Access Compliance Report

Public Rights-of-Way

(Curb Ramps)

Intersection ID: 5073	Main Street: FROSTMOOR_PL	Cross Street: HEDGECREST_PL	Location: SW
ADA ID: C5A9FA137E6D	Ramp Type: Perp	Initial Pass/Fail: Fail	Overall Compliance: No
Severity Score: 33.75			
Codes/Mitigation Info/Possible Solution		Field Measurements/Component Compliance

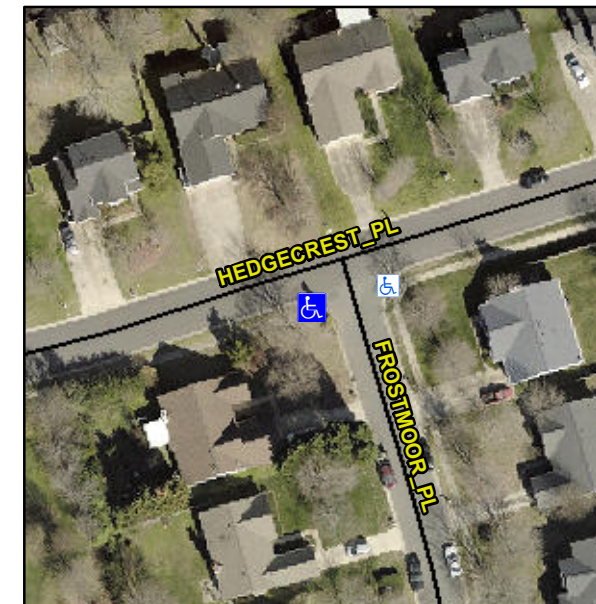
Not Found, R304.5.1, R304.2.2

Compliance	Description	Data	Compliance	Description	Data
N/A	Ramp Length (in)	51.0	No	Ramp Slope (%)	14.3
No	Ramp Width (in)	47.0	Yes	Ramp XSlope (%)	1.3
N/A	Flare Type LT	N/A	N/A	Flare Type RT	N/A
N/A	Flare Slope LT (%)	N/A	N/A	Flare Slope RT (%)	N/A
N/A	Flare Traversable LT?	N/A	N/A	Flare Traversable RT?	N/A
N/A	Landing Length (in)	N/A	N/A	DWS Provided?	N/A
N/A	Landing Width (in)	N/A	N/A	DWS Contrast?	N/A
N/A	Landing Slope (%)	N/A	N/A	DWS Length (in)	N/A
N/A	Landing X Slope (%)	N/A	N/A	DWS Full Width?	N/A
N/A	Landing Curb? (Y/N)	N/A	N/A	DWS Offset (in)	N/A
N/A	Shared Landing?	N/A			
N/A	Gutter Ponding?	N/A	N/A	Gutter Slope (%)	N/A
N/A	Gutter Lip Ht (in)	N/A	N/A	Gutter X Slope (%)	N/A
N/A	Painted X Walk1?	No	N/A	Painted X Walk2?	N/A
	X Walk 1 Direction	To E		X Walk 2 Direction	N/A
N/A	X Walk 1 Width (in)	N/A	N/A	X Walk 2 Width (in)	N/A
	X Walk 1 Slope (%)	2.3		X Walk 2 Slope (%)	N/A
	X Walk 1 X Slope (%)	1.0		X Walk 2 X Slope (%)	N/A

Remove & Replace Entire Ramp.
